**Metropolitan Region Scheme Amendment  
No. 1010/33 - Port Catherine**

**Report and recommendations  
of the Environmental Protection Authority**

**Environmental Protection Authority  
Perth, Western Australia  
Bulletin 1060  
[August 2002]**

**Figure 6: Marine Habitats**

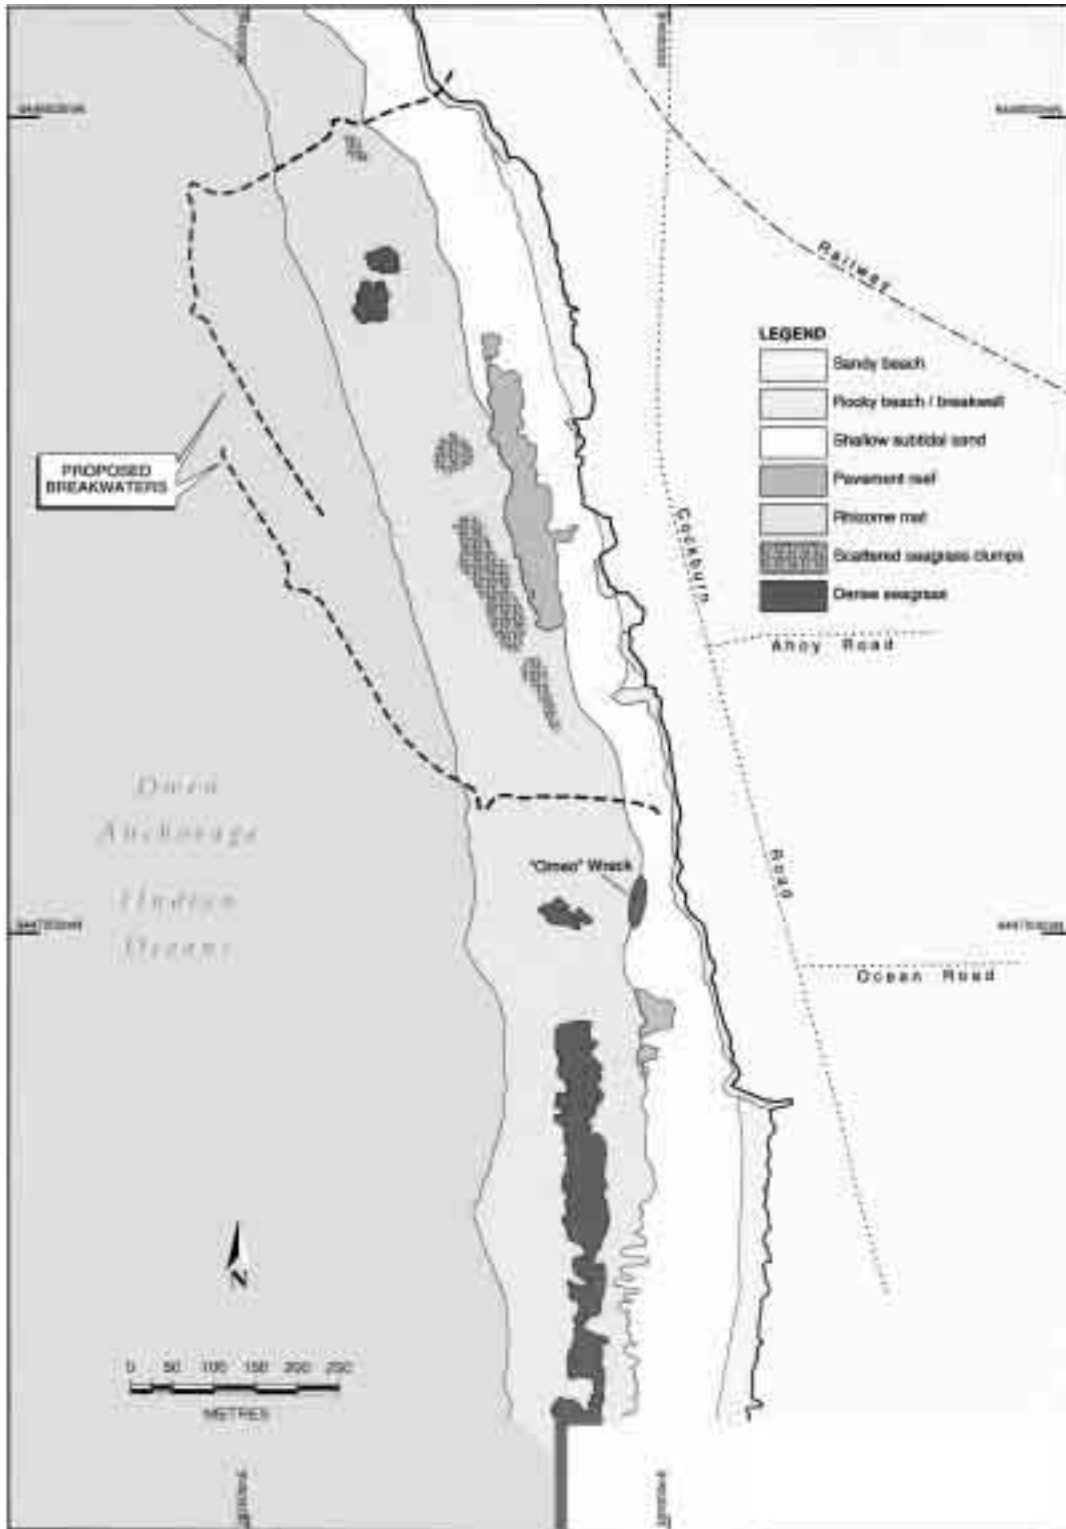
MRS Amendment No. 1010/33 proposes to zone approximately 30 hectares of the Owen Anchorage 'Waterways' reservation to 'Urban' to allow for the construction of the Port Catherine marina. Within this area, there is approximately 0.3 hectares of *Posidonia sinuosa* seagrass meadow which would be lost if the proposal is implemented. Of this 0.3 hectares, 0.27 hectares is dense seagrass (>75% cover) and 0.03 hectares is scattered seagrass (<25% cover) (refer to *Figure 6: Marine Habitats*).

The marina also has the potential to impact on seagrass outside of the amendment area. This impact can occur through sediment plumes created at the time of construction, impacts on the seabed from altered wave action or shading from increased algal growth. Two areas of seagrass occur in the vicinity of the marina, the first is a small patch of less than 0.2 hectares of dense seagrass located 130 metres south of the proposed marina, the second is a large and dense seagrass meadow located 275 metres to the south and beyond (refer to *Figure 6: Marine Habitats*). The proposed marina has been modified from previous designs to avoid impacting these areas.

A number of submissions questioned the acceptability of the proposed seagrass losses, and whether the cumulative impacts of these losses had been adequately considered. Another prominent issue was the loss of the potential for seagrass to regenerate in the area of the amendment. The calculation of the areas of seagrasses within Owen Anchorage was also disputed.

With respect to loss of seagrass habitat, the proposed marina would remove less than 0.45% of the potential seagrass habitat within Owen Anchorage. On this basis, this impact is considered so small that it would not compromise the EPA's objective, cumulative or otherwise. The EPA also recognises that the potential for seagrass to regenerate within or immediately adjacent to the location of the proposed marina is low.

it is the opinion of the EPA that the proposal can be managed to meet the EPA's environmental objective for this factor, provided that the Recommended Environmental Conditions, as set out in Appendix 4, are incorporated into the Metropolitan Region Scheme.

Figure 8: Soil Remediation

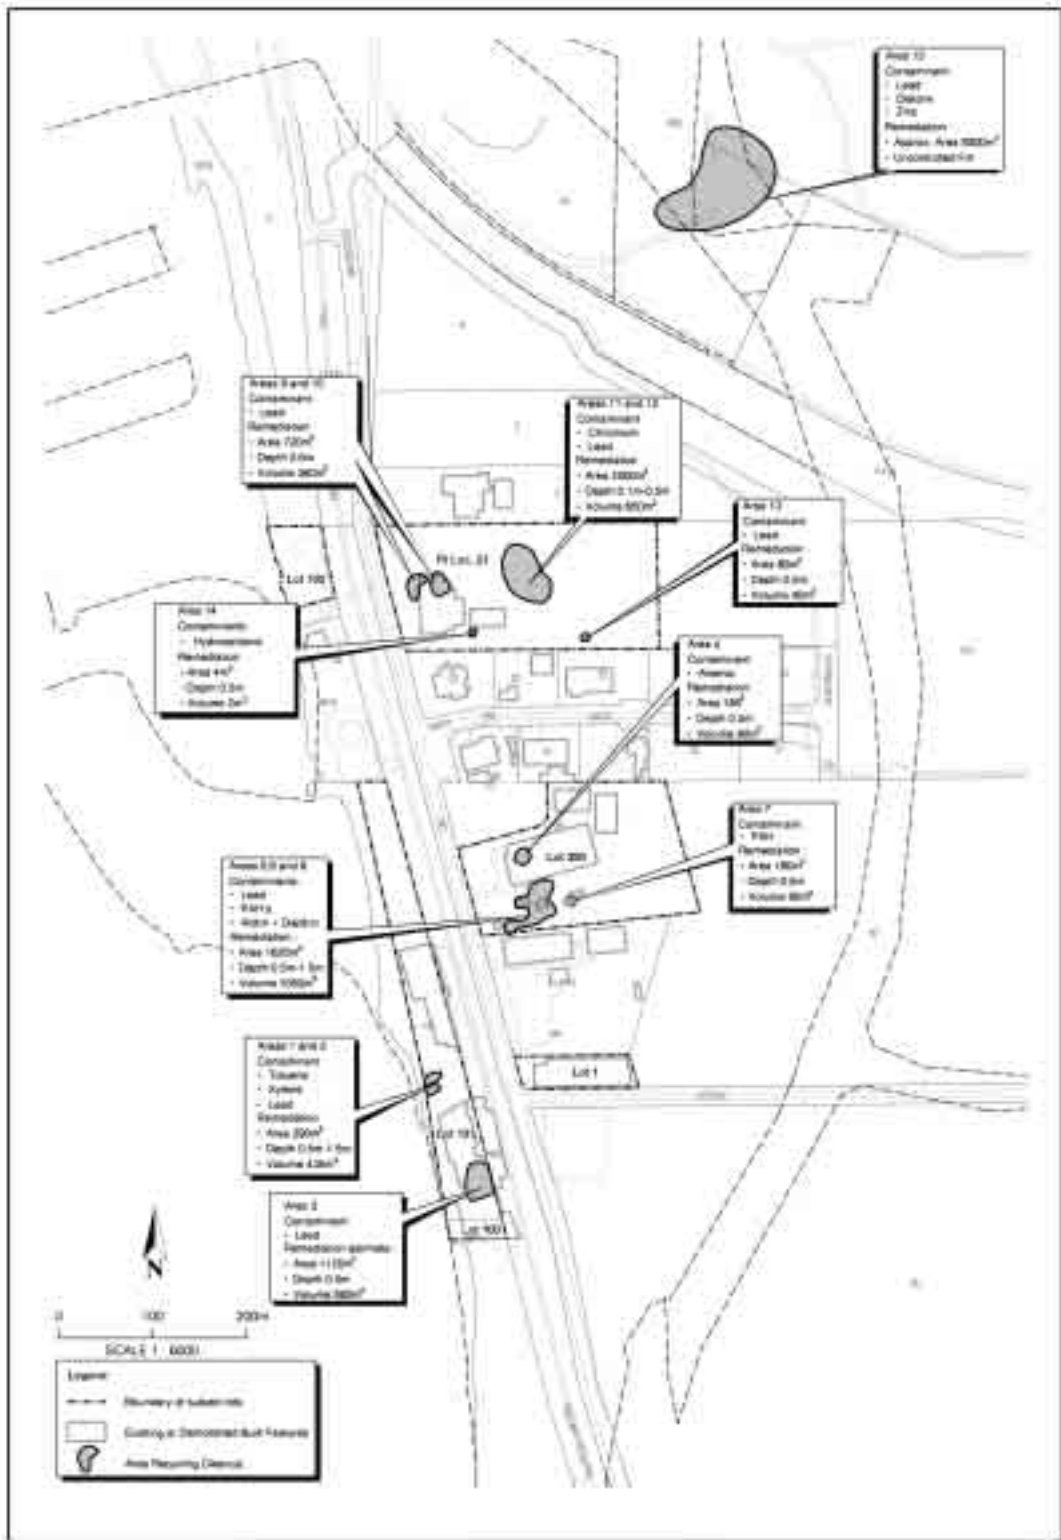
Many public submissions raised the soil contamination issue in a general sense. Nearly all of these supported the remediation of the land, but were non-technical in nature and did not specifically comment on the contamination assessment or remediation strategy. However, the submission from the Department of Health requested clarification on a number of the inputs into the Human Health Risk Assessment and indicated a possible threat from asbestos contamination that had not been addressed previously.

The Human Health Risk Assessment and the Fate and Transport modelling identified a number of areas that would require remediation should the amendment be implemented. This remediation includes the removal of 3050m<sup>3</sup> of soils that exceed safe levels of contamination for human health, 227m<sup>3</sup> of wastes that have a negative aesthetic impact and 5000m<sup>3</sup> of uncontrolled fill (refer to *Figure 8: Soil Remediation*). These contaminated materials are to be disposed of off-site at approved landfill facilities.

With respect to the issues raised in the submission from the Department of Health, the WAPC provided additional information regarding the Health Risk Assessment. The Department of Health has since advised that the Health Risk Assessment now meets its requirements. On the issue of managing the potential for asbestoses contamination, the WAPC is now proposing that an Asbestos Management Plan be prepared for the site. The Asbestos Management Plan would be prepared as part of a Construction Management Program that would detail how works over the site are to be conducted to control environmental and health impacts. It is proposed that the Construction Management Program would be prepared prior to approval to a subdivision or development proposal.

It is also proposed to prepare a Remedial Works Management Program prior to approval to a subdivision or development proposal. The Remedial Works Management Program will detail the process for the site to be cleaned-up and validated.
